NEW TENSIONER PULLEY KIT/ SET WITH ENGINE MOUNT FOR CHEVROLET/OPEL/VAUXHALL 1.7-L DIESEL ENGINES

TECHNICAL INFO NO. 1043

Image 1: Replaced tensioner pulley 55316 (1) and its successor 55383 (2)

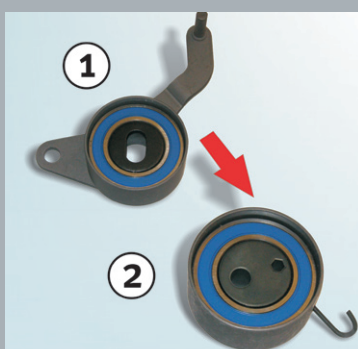
The existing tensioner pulley with part number 55316 will be replaced by the tensioner pulley with part number 55383 (see Image 1).

Image 2: Package contents: 5538370

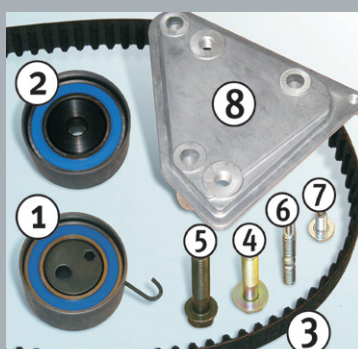
As part of this conversion, models up to engine number 328704 must be fitted with a new engine mount (see Image 2, Item 8).

For this reason, RUVILLE provides the tensioner pulley kit 5538370 and tensioner pulley set 5538350 for the conversion process. Both products include a new engine mount.
